UNITED STATES PATENT AND TRADEMARK OFFICE

| APPLICATION NO. | FILING DATE | FIRST NAMED INVENTOR | ATTORNEY DOCKET NO. | CONFIRMATION NO. |
|--------------------------|-------------|----------------------|---------------------|------------------|
| 10/724,966 | 12/01/2003 | Lee J. Brown | 1612 | 3032 |

| Office Action Summary | Application No. 10/724,966 | Applicant(s) BROWN, LEE J. | |

DETAILED ACTION

Claim 1: Sasamoto discloses a support bracket (FIG. 1a) comprising:

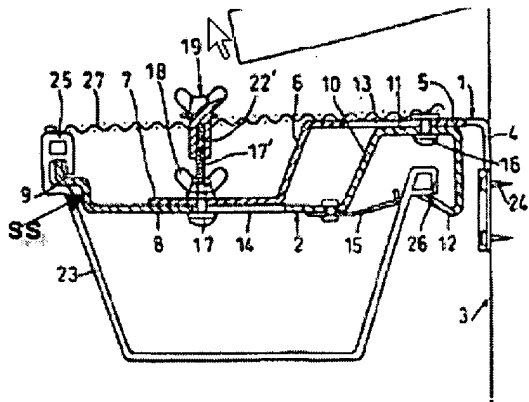
a unitary (in that it is a unitary device) substantially L-shaped body including a first leg (the portions 6, 5, 4, 10, 11, 12) that extends vertically, and a second leg (portions 7, 8, 9) that extends horizontally when installed, the first leg including a mounting surface (12) adapted to contact a rear wall of the gutter and a front surface (10) spaced from the mounting surface and connected therewith by a central panel (11) that extends in a longitudinal direction (where 11 extends in the same longitudinal direction of element 10 of the first leg) of the first leg and interconnects the mounting surface and the front surface (FIG. 1), the second leg including a support surface (shown as element ss in the annotated figure below) spaced from the mounting surface for supporting a front edge of the overlying gutter cover panel;

at least one first bore (apertures that receive fasteners 24) for securing the bracket to a building surface;

at least one second bore for receiving a cover fastener (aperture hole 14 for example, FIG. 1, 2a, are for connecting a cover panel 27 to the bracket, where hole 14 is in the front portion of the cover, thus meeting the functional limitation of the claimed bore);

engagement means (portion 9) carried by the second leg for engaging and supporting a front wall of the gutter (FIG. 1); and

upwardly-facing flat support surface means (6, 5) for engaging and supporting a rear surface portion of the gutter cover panel.

Claim 2: The Sasamoto first leg includes at least two bores spaced from each other along the first leg (two fasteners 24 are extended through two bores in portion 4; FIG. 1).

Claim 8: The Sasamoto second leg carrying a stop surface (the end of element 20, FIG 1) for abutment with and positioning relative to the bracket of a front edge of a gutter cover panel.

Claim 11: The Sasamoto at least one aperture is positioned in the first leg (FIG 1).

Claim 14: Sasamoto discloses a support bracket (FIG. 1a; where it is noted that the support bracket of Sasamoto is capable of being used with a rain gutter that includes a cover panel having an inturned front edge) comprising:

a unitary (in that it is a unitary device) substantially L-shaped body including a first leg (the portions 6, 5, 4, 10, 11, 12) that extends vertically, and a second leg (portions 7, 8, 9) fixedly connected to the first leg, the second leg extends horizontally when installed, the first leg including a mounting surface (12) adapted to contact a rear wall of the gutter and a front surface (10) spaced from the mounting surface and connected therewith by a central panel (11) that extends in a longitudinal direction (where 11 extends in the same longitudinal direction of element 10 of the first leg) of the first leg and interconnects the mounting surface and the front surface (FIG. 1), the second leg including a support surface (shown as element ss in the annotated figure above) spaced from the mounting surface for supporting a front edge of the overlying gutter cover panel;

Claim 15: Sasamoto discloses a support bracket (7, 8; FIG. 2a; where it is noted that the support bracket of Sasamoto is capable of being used with a rain gutter that includes a cover panel having an inturned front edge) comprising:

engagement means (the upward vertical portion of 9) carried by the second leg for engaging a front wall of the gutter (FIG. 1);

Claim 16: The Sasamoto bracket includes at least one second bore for receiving a cover fastener (aperture hole 14 for example, FIG. 1, 2a, are for connecting a cover 27 to the bracket, where the hole 14 is in the front portion of the cover, thus meeting the functional limitation of the claimed bore).

Claim 18: The Sasamoto contact surface includes stop (horizontal portion 9 provides a stop of element 25).
